**FIRST ADDENDUM TO INVITATION TO BID
FOR FOOTHILL DRIVE SANITARY SEWER UPGRADE. 7207**

CLEAN WATER SERVICES

ISSUED: JULY 2, 2026

**7207 FOOTHILL
DRIVE SANITARY
SEWER UPGRADE**

SITE PLAN 1

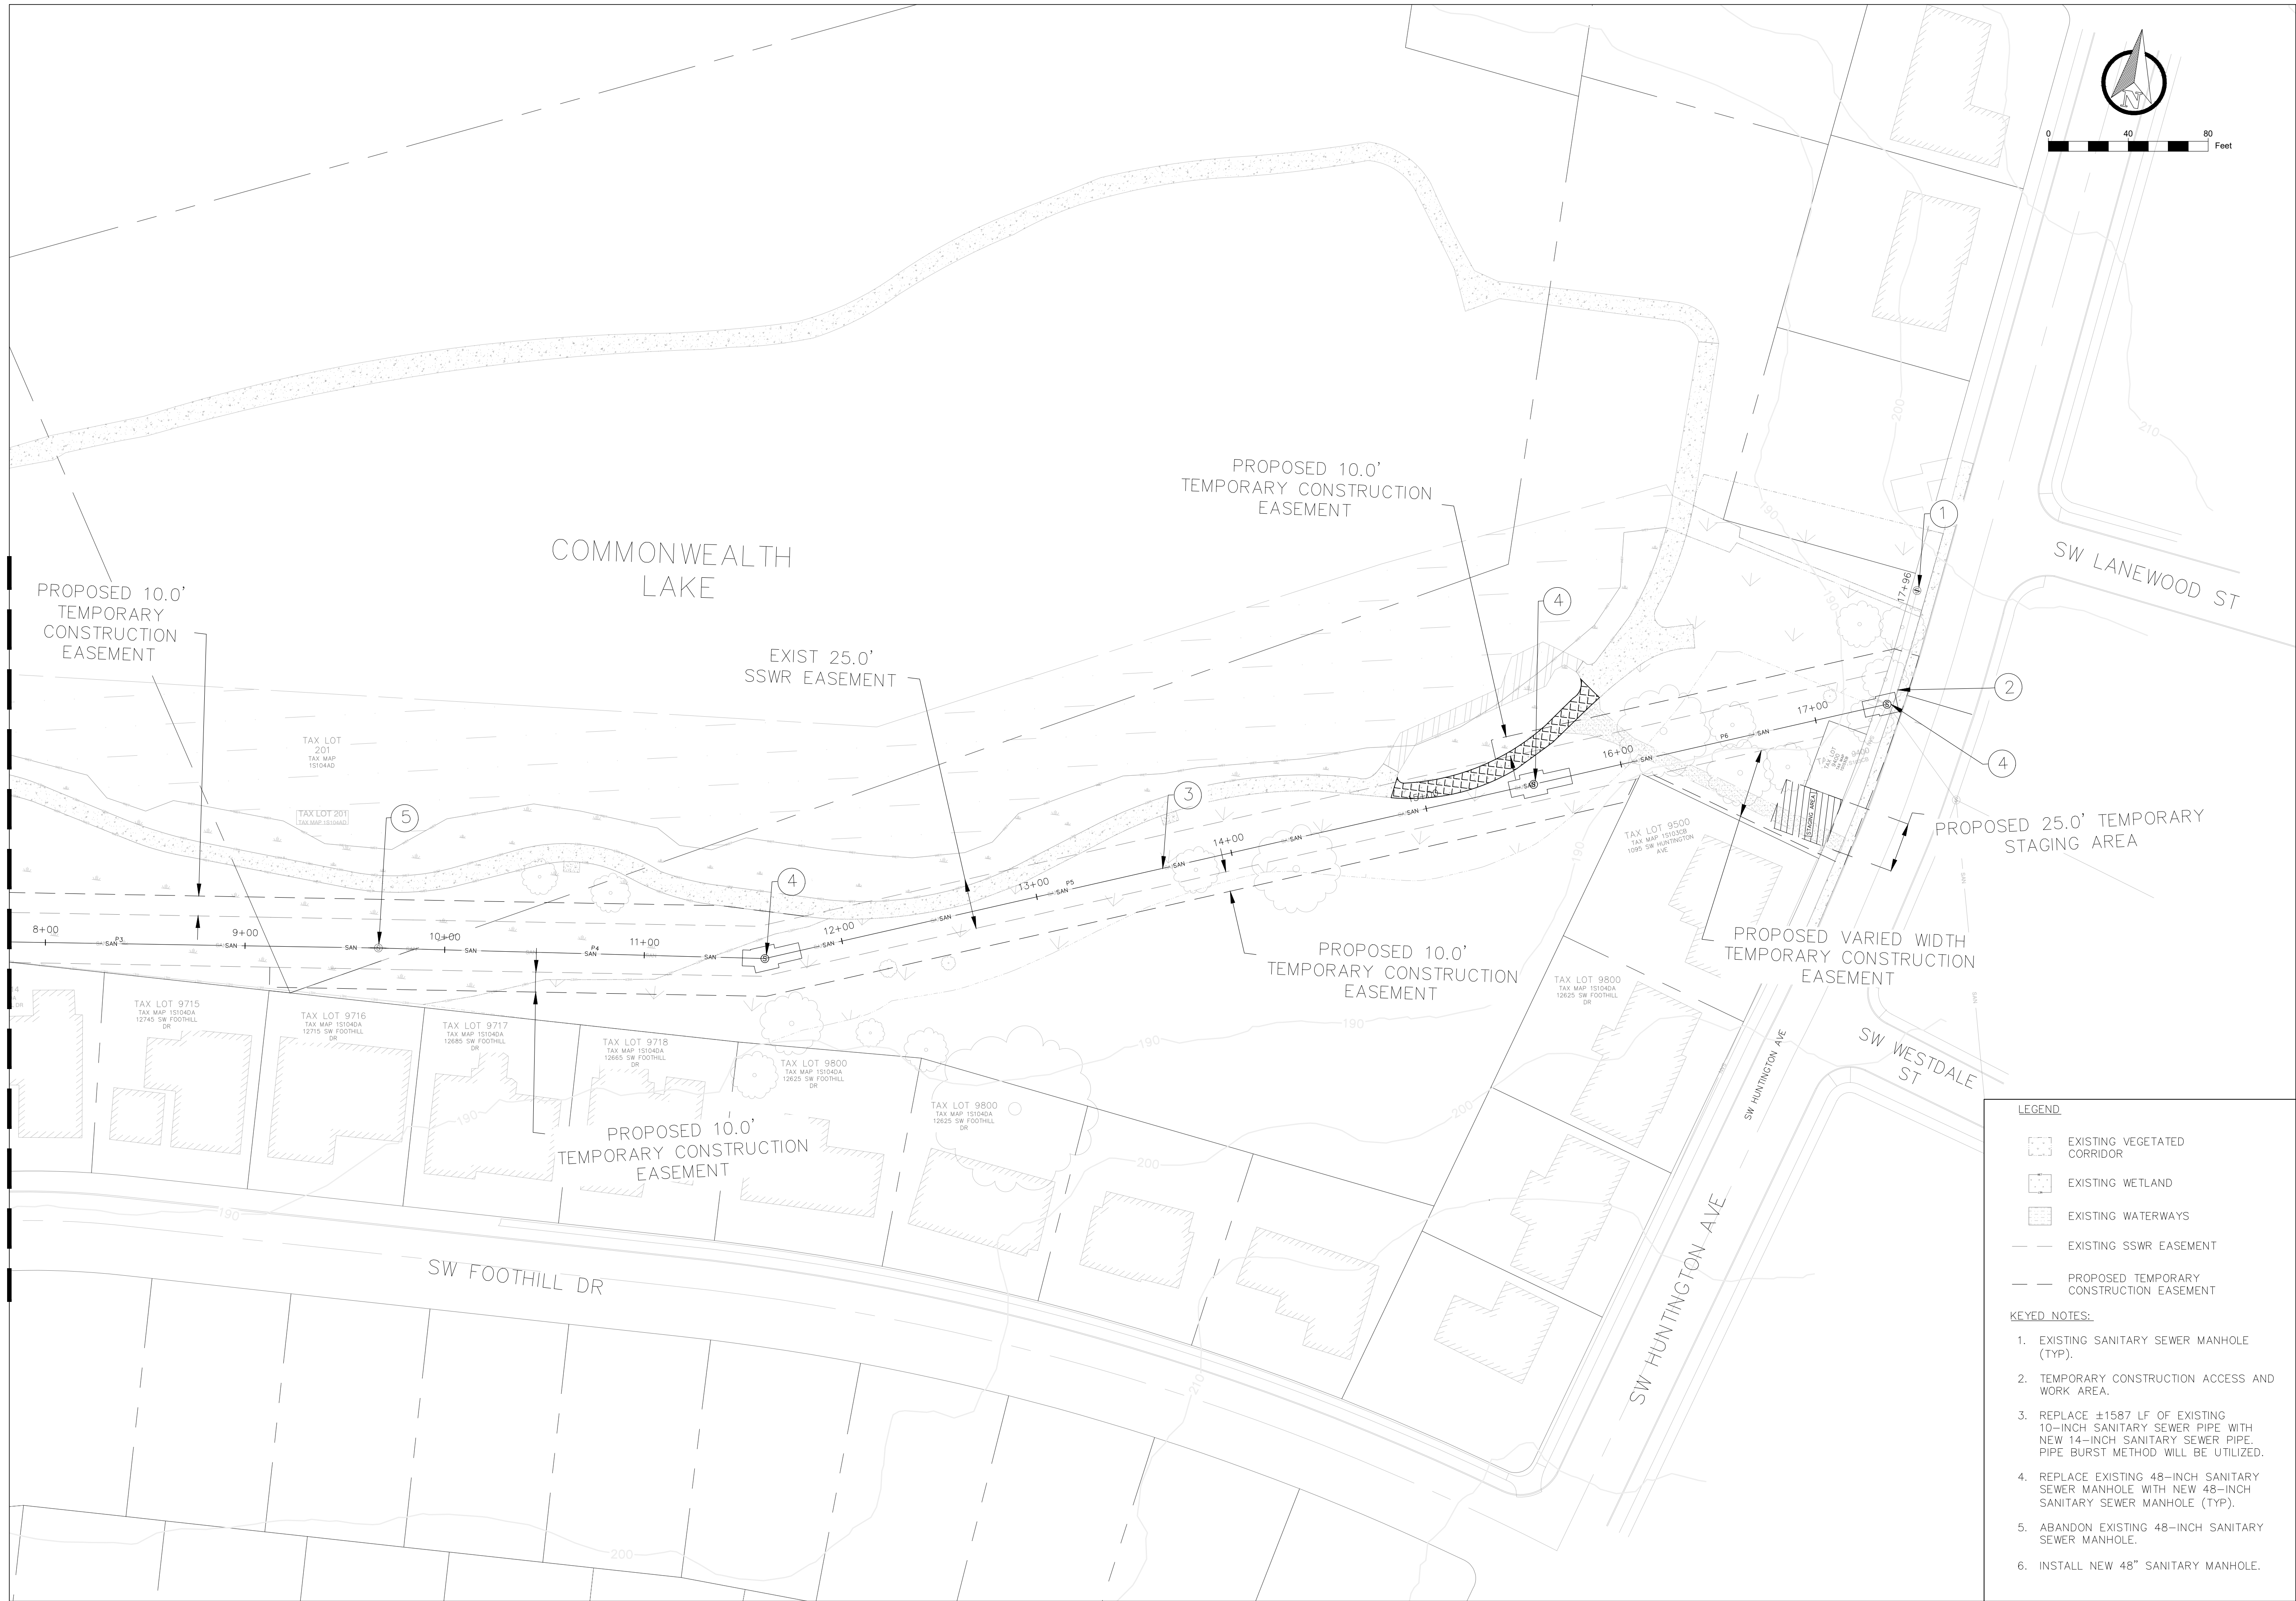
- a. Updated Schedule of Bid Prices sheet
- b. Updated drawing sheets –
 - Sheet 03 (Site Plan 1): Changed the Manhole legend at Sta. 4+78.00
 - Sheet 04 (Site Plan 2): Manhole at station 9+66.77 will be abandoned not removed. Changed the Manhole legend at Sta. 9+66.77 and removed the excavation trench linework.
 - Sheet 07 (Plan and Profile Sta 7+00 to Sta 12+00): Manhole at station 9+66.77 will be abandoned, not removed. Changed the Manhole legend at Sta. 9+66.77 and removed the 10x10 manhole removal trench linework. The manhole label in the profile is also updated as Abandon Existing Standard 48” Manhole #11646.
 - Sheet 08 (Plan and Profile Sta 12+00 to Sta 17+96): Added label to Manhole #11649 in profile view
- c. Signed THPRD approved Permit of Entry/ Temporary Construction Agreement
- d. Non-Mandatory Pre-Bid Meeting Sign-in Sheet and Agenda

SITE PLAN 2

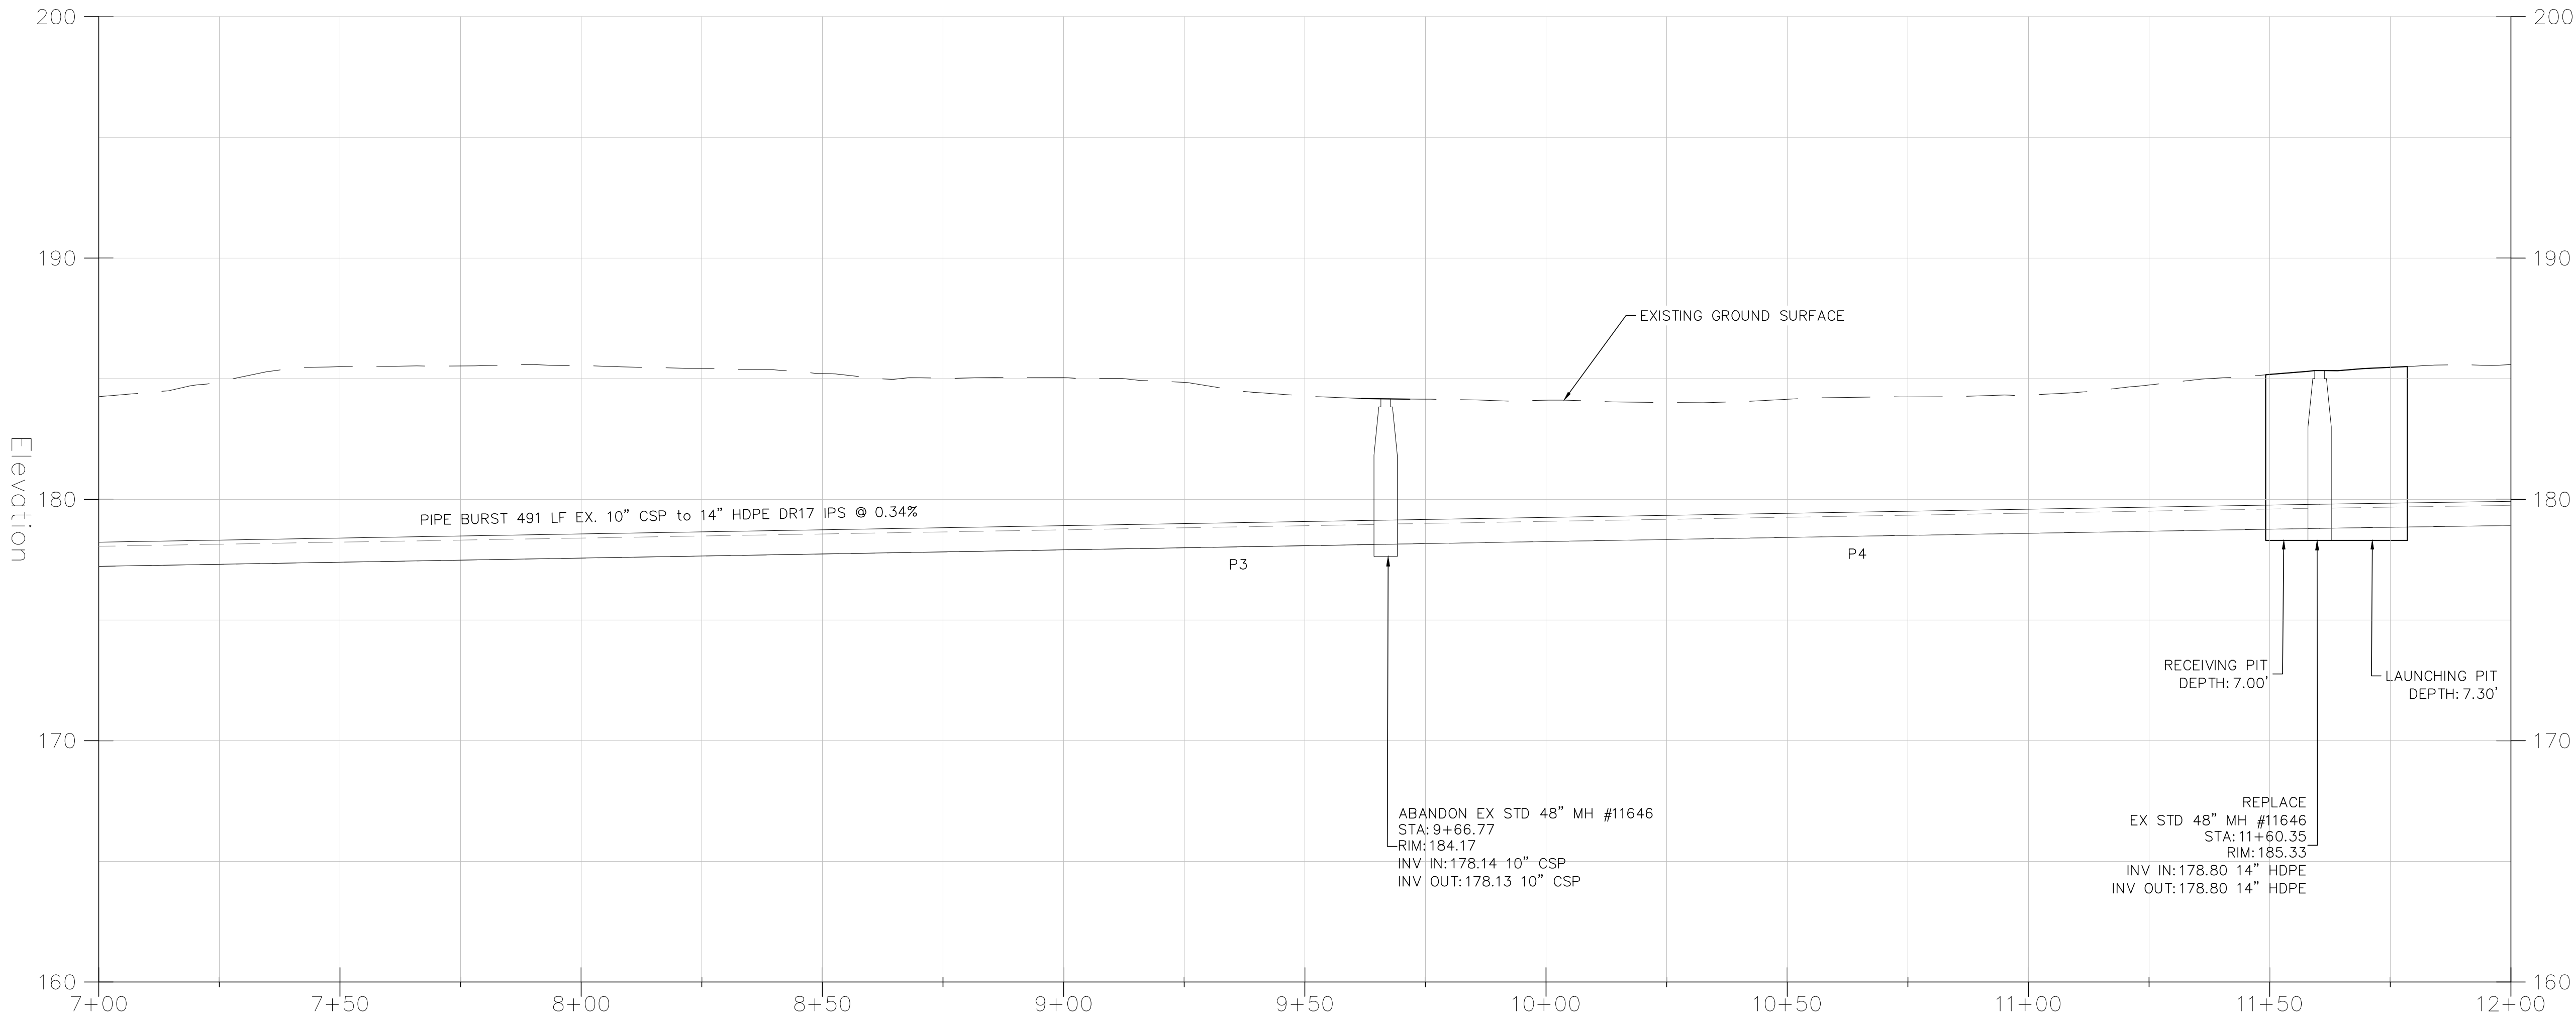
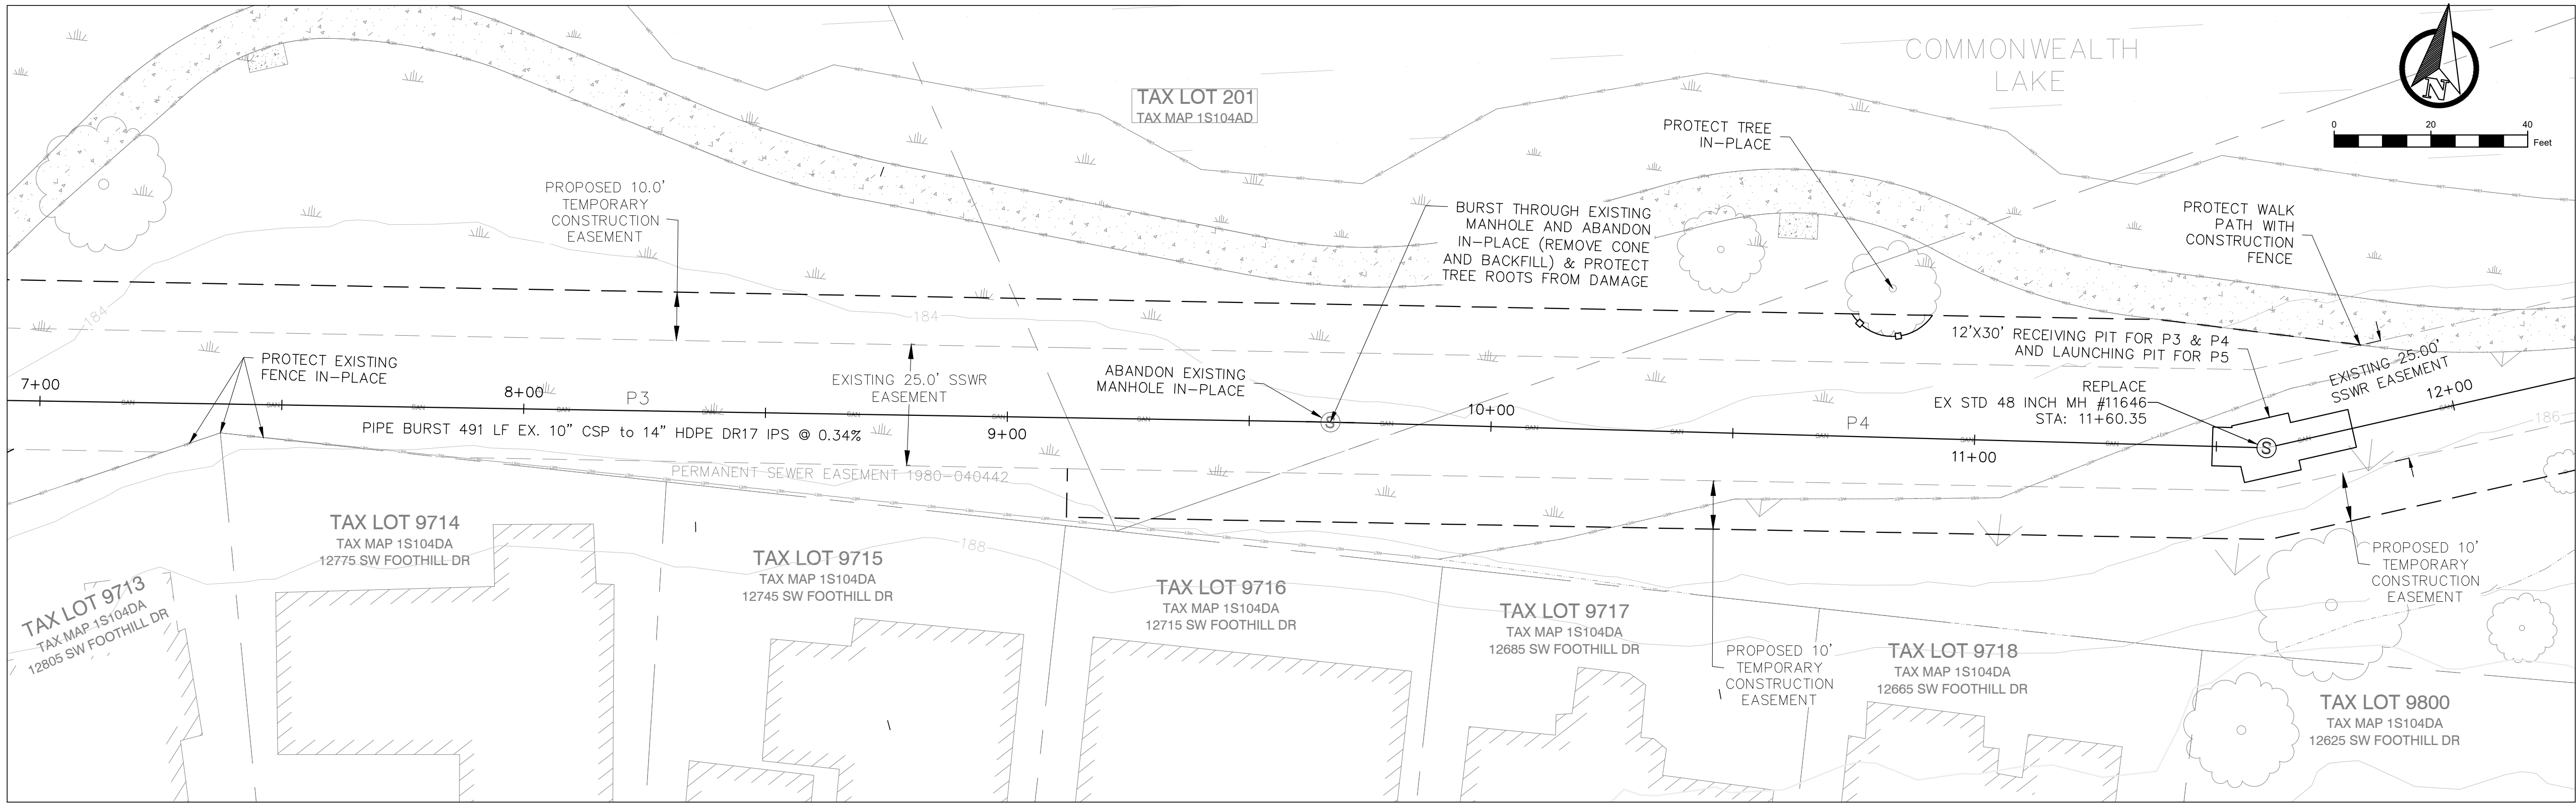
Question 2: Bid item 8: install MH = 7ea. i counted only 6. there are 5 labeled replace, 1 labeled new, then sht 7 sta. 9+66.77 labelled remove but drawn like the others to be replaced. is this the 7th mh just mis-labeled?

Answer 2: Yes, the Manhole at Station 9+66.77 (Sheet 07) is mis-labeled, this manhole will be abandoned in-place. We will update the quantity to 6 on the bid tab sheet and upload the new version with the upcoming Addendum 1.
